FINAL DIVISION OF SAFETY SYSTEMS INTERIM STAFF GUIDANCE
DSS-ISG-2010-01
Revision 0

**STAFF GUIDANCE REGARDING THE NUCLEAR CRITICALITY SAFETY ANALYSIS FOR
SPENT FUEL POOLS**

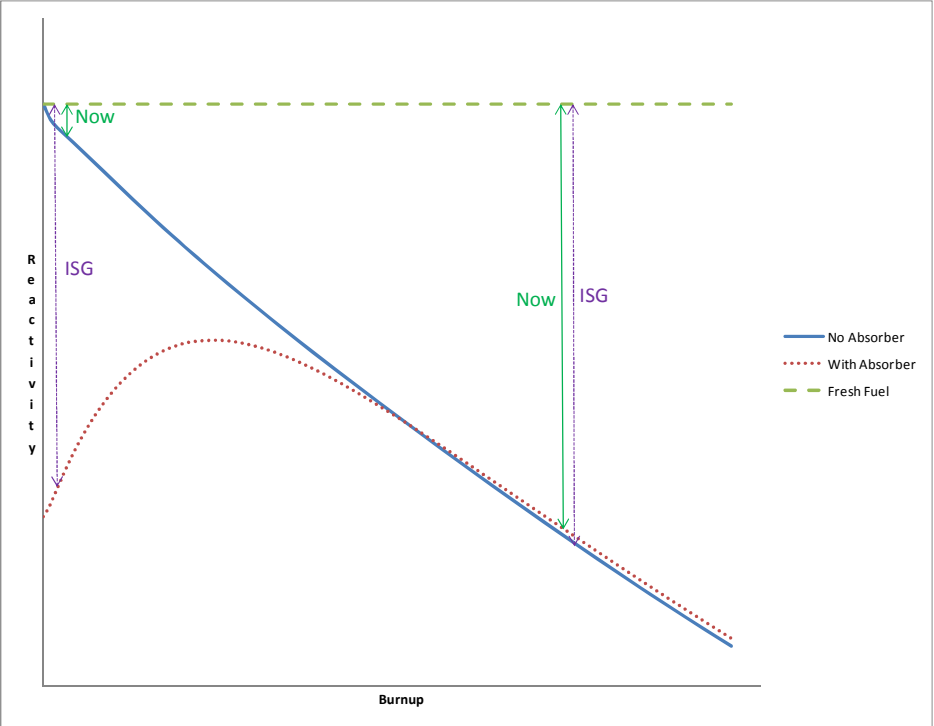
NO.	ISG Section	COMMENT	NRC Response
		<p>2. The wording “with or without residual neutron absorber” in this section creates an inconsistent application of conservatisms in two cases as described below. Please consider revising this section.</p> <p>Case 1: The first inconsistency impacts the application of the depletion uncertainty at low burnups with burnable neutron absorbers (IFBA, Gd, erbia, WABA, BPRA, Pyrex, etc). As shown on the left side in Figure 1 (provided at the end of this attachment), the difference in reactivity between an assembly that contains burnable absorbers versus an assembly that does not contain burnable absorbers is significant at low burnups. Applying 5% of the reactivity difference between the fresh assembly and the assembly with burnable absorbers would suggest that a significant conservative uncertainty be applied even in the case where the residual neutron absorber is not credited in the low burnup assembly. This would also create a large discontinuity in the maximum k_{eff} (which includes all biases and uncertainties) between the fresh fuel assembly where integral absorber is not credited in the spent fuel pool and the slightly burned fuel assembly, where the large “depletion uncertainty” would be applied according to the prescription in the draft ISG. Neglecting the residual burnable absorber is a much more significant conservatism than applying the 5% depletion uncertainty and therefore it is not necessary to apply both of these conservatisms.</p> <p>Case 2: The guidance as written would recommend a double application of conservatisms from two separate configurations. To illustrate this point, Figure 1 shows the reactivity of two fuel assemblies in a representative spent fuel storage rack as a function of burnup. The first</p>	<p>be essentially no change in reactivity, thereby rendering the reactivity change ineffective in estimating the depletion uncertainty.</p> <p>2. In Case 1 the commenter presents a scenario with the fuel assembly having a large initial BA loading. The commenter’s figure appears to show that for fuel assemblies with large initial BA loadings the DSS-ISG guidance on determining the depletion uncertainty will be unnecessarily conservative at lower burnups. The NRC staff agrees that there will be cases at low burnups where following the ISG guidance could be unnecessarily conservative. However, as pointed out in NEI comment 7.1 burnups in this range are rarely credited. The NRC staff does not believe it is productive to provide guidance for something that may not occur during the life of the DSS-ISG. Additionally, the NRC staff believes that more moderate BA loadings will result in less dramatic conservatisms, and the NRC staff guidance should consider those scenarios as well.</p>

NO.	ISG Section	COMMENT	NRC Response
		<p>assembly (dotted line) includes burnable absorbers, while the second assembly (solid line) is identical to the first, only without the burnable absorber. The reactivity of the fresh fuel assembly is also shown as the horizontal (dashed) line. If the draft guidance were followed verbatim, the depletion uncertainty would have to be calculated based on the difference in reactivity of the fresh fuel assembly and the assembly that contained no neutron absorber, because it has the lower reactivity at higher burnups as shown in the left of Figure 1. However, as suggested by ISG Section IV.2.c, burnable absorbers must be considered in their effect of hardening the spectrum and providing a more reactive fuel assembly at the same burnup and enrichment. As a result, the NRC has specified in the draft ISG the application of conservatisms from two different physical configurations.</p> <p>3. The definition of reactivity decrement suggested here is arbitrary and inconsistent with physical reality as discussed above. To be consistent, the guidance should read that the reactivity decrement should be the largest of the following three scenarios (noting that all might not be applicable to a specific criticality analysis application): (1) the difference in the k_{eff} of a fresh unburned assembly with no burnable poison to the k_{eff} of the same assembly with the credited amount of burnup; (2) the difference in the k_{eff} of a fresh unburned assembly with no burnable poison to the k_{eff} of the same assembly with the credited amount of burnup, depleted with a fixed burnable absorber to the maximum burnup permitted with the fixed burnable absorber present, but with the fixed burnable absorber removed at the credited burnup; or (3) the difference in the k_{eff} of a fresh unburned assembly with an integral poison present to the k_{eff} of the same assembly with the credited amount of burnup,</p>	<p>In Case 2 the comment indicates that there is a double application of conservatisms. Consideration of the burnable absorber effect on the final reactivity of a depleted fuel assembly is not a conservatism. The delta shown in the figure is small. 5% of the delta would likely have a negligible impact on the total final estimated k_{eff} and therefore does not warrant separate guidance.</p> <p>Therefore, no change was made to the guidance and as with any guidance, applicants can use alternate methods, provided those methods are technically sound.</p> <p>3. The DSS-ISG guidance does contain a bit of artificiality. However, the guidance continues the Kopp Letter guidance of using a reactivity decrement to estimate the depletion uncertainty. The DSS-ISG guidance on how to determine the reactivity decrement includes scenarios the Kopp Letter does not, as noted in the NRC staff response to NEI comment 7.1. The DSS-ISG guidance is simple and should be conservative over all scenarios. The commenter's suggestions would not be</p>

NO.	ISG Section	COMMENT	NRC Response
		<p>depleted to that credited amount of burnup with the integral absorber present, and with the residual integral burnable absorber present.</p> <p>4. This section narrowly discusses single assemblies, while sometimes cell combinations are analyzed. For example, if a 2x2 array in the pool is analyzed and qualified to have 3 spent fuel assemblies and one empty cell, then the reactivity change associated with a single assembly (i.e. infinite array of assemblies) would be overly conservative as the basis for the depletion uncertainty, and the reactivity change associated with changing the three assemblies in the array to three fresh assemblies would be more appropriate. The text should be changed to consider such conditions.</p>	<p>conservative over all scenarios. As with any guidance, applicants can use alternate methods, provided those methods are technically sound. Therefore these recommendations were not incorporated into the DSS-ISG.</p> <p>4. The comment notes that as storage configurations change the burnup of interest can change. DSS-ISG-2010-01 states the reactivity change will be based on the "...burnup of interest..." Therefore, these scenarios are already covered and no change to DSS-ISG-2010-01 has been incorporated.</p>
